FLIGHT READINESS STATEMENT
STS-90/ET-91
EXTERNAL TANK PROJECT
PRE-FLIGHT REVIEW

Space Shuttle
External Tank

STS-90/ET-91
Pre-Flight Review

STS-90/ET-91
Delta Pre-Flight Review

Revised Intertank Foam Thickness

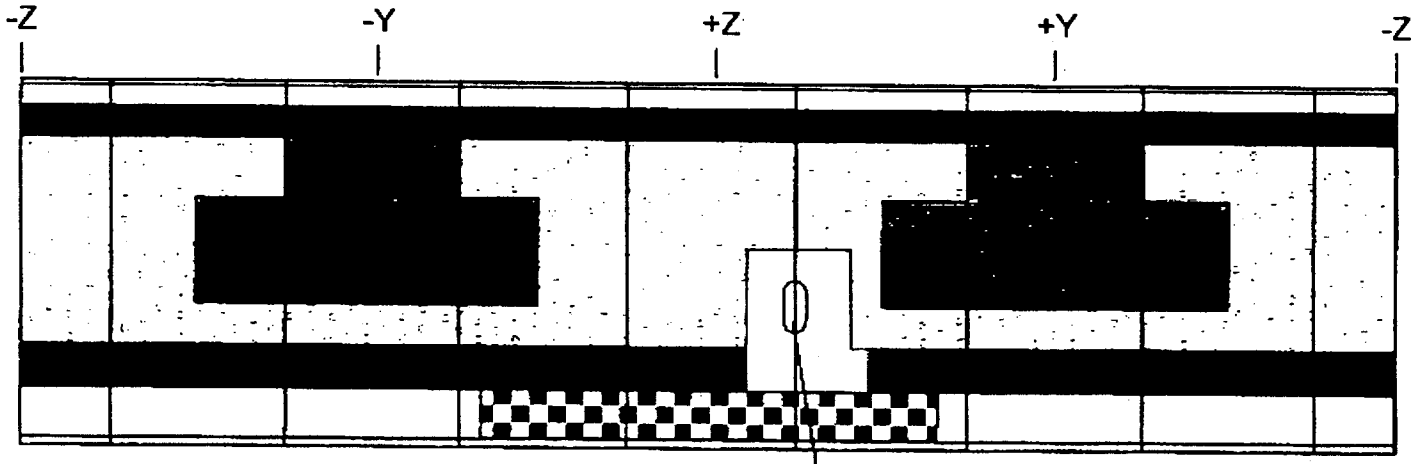
- Hardware
  - Reduced minimum Intertank foam thickness
  - Machined Intertank stringer panel foam to near minimum required thicknesses
    - Reversed fastener installation to reduce fastener head protrusion on outside panel surfaces where possible to accommodate machining
- Manufacturing
  - Implemented a new delivery system to control foam thickness to tighter tolerance and tailored thicknesses
  - Developed new machining facility with software mapping tool, cutting head and dust collection/environmental control system
- Documentation:
  - Revised HCS to reflect new TPS configuration

- Reduced minimum foam thickness on Intertank
- Implemented new foam delivery system for Intertank

- Early incorporation of change on ET-91 diminishes number of first time changes for SLWT
  - Reduction of TPS average thickness provides a 150 lb weight savings

- Analysis
  - Stress: New configuration meets required FS of 1.10
  - Thermal: Adequate foam exists to maintain structural temperature requirements
- Inspection: Verifies proper appearance of foam
  - Lead in/lead out plus additional plug pulls
    - Required: 30 psi
    - Lead in/lead out: 64.5/58.4 psi
    - 2 additional plug pulls: 52.2/44.2
  - Lead in/lead out density
    - Required = 2.0-2.6
    - Actual = 2.39/2.38
  - Thickness met all requirements
    - Verified by ≈ 5,000 pin gage measurements

Sanded Foam Intertank Thrust Panels

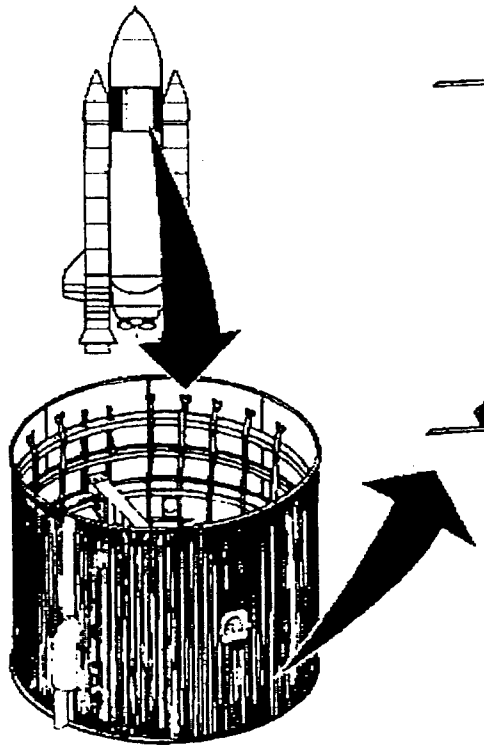
- Reduced Intertank foam thickness on Intertank thrust panel
  - Performed plug pulls to reverify TPS strength properties

- STS-87/OV-102 had much greater than average lower surface tile damage (109 hits > 1" on lower surface)
  - Fault tree investigation indicated TPS debris from Intertank thrust panel most probable cause of Orbiter tile damage

- Removed foam from rib tops
  - Maintained foam minimums to + 0.20"
  - Minimums vary from 0.25" to 0.35" depending on location
  - During rind removal operations, one area of localized overtrimmed foam was accepted use as is per MRB

- Station 912 - 914 on +Y thrust panel: Machined to 0.187" (requirement = 0.35 min.)
      - Low foam area is in non-cryogenic zone - No ascent/entry heating concern

- Removed rind material only from thrust panel valleys
  - During rind removal operations, two areas of localized overtrimmed foam were accepted use as is per MRB

- Station 945 - 950 on -Y thrust panel: Machined to 0.28" (requirement = 0.35 min.)
      - Low foam area is in non-cryogenic zone - No ascent/entry heating concern

- Station 894 on +Y thrust panel: Exposed two fastener heads
      - Thermal analysis of temperatures in this localized area indicates surface temperatures $\approx$ 150°F

- Fasteners designed for use up to 450°F
- Three successful plug pulls on each thrust panel reverified material strength

- Rind removal provides better TPS strain capability
- Reduced foam height reduces airload on foam from crossflow
- Removal of rind eliminates denser material layer
- Material less likely to come off in large pieces
- Material less damaging
- Reduces outer fiber bending stresses from meridonal flexure
- RAP compression and density lower than ET-90 but meets requirements
- Data review shows ET-91 tensile acceptance and KSC retests much higher than ET-89 thru ET-90

ET RSS Deletion (Phase III)

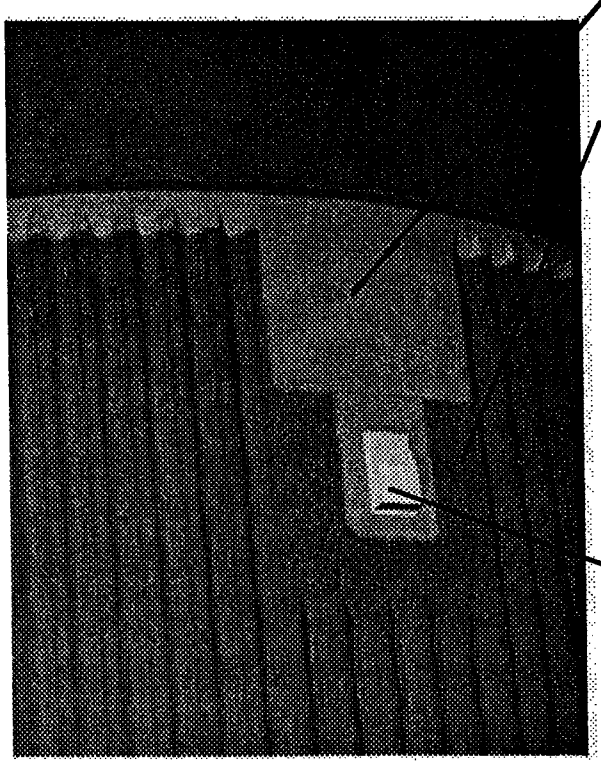
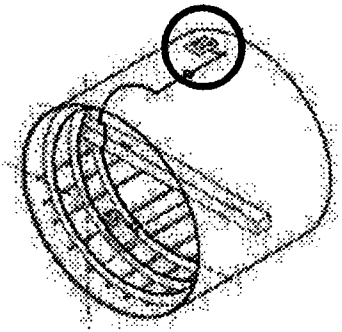
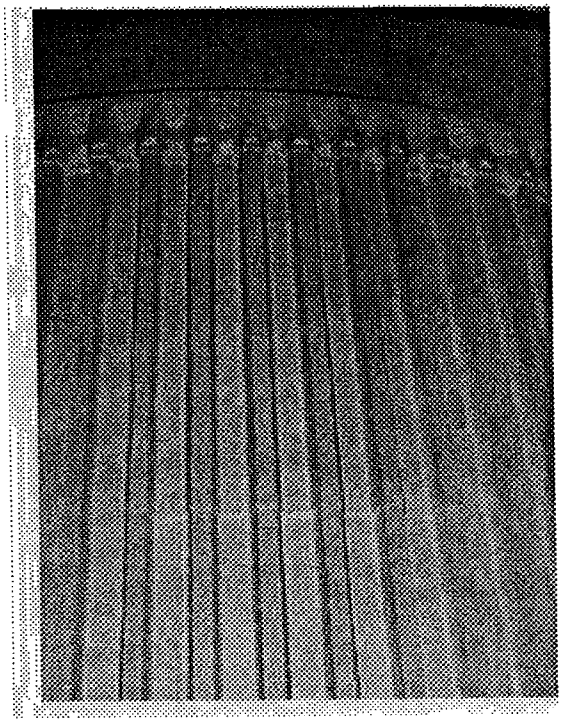
RSS Antenna / Ground Plane deleted

Change: Continued deletion of ET RSS hardware (B02011, Phase III)

- Deleted RSS antennas, mounting brackets and cabling in LH2 tank cable trays
- Installed blank-off plate where antennas were previously mounted
  - Modified foam machining program to accommodate revised configuration
- Replaced MA25 cable trays with SLA cable trays
  - Installed rubber dams without provisions for cabling

- Analysis
  - Dynamics: Negligible loads change due to RSS hardware deletion
  - Stress
    - Intertank: FS > 2.0, unchanged (failure mode - tension)
    - Cable tray SLA: FS > 2.0, unchanged (failure mode - strain)
  - Venting: Mass flow rates unchanged
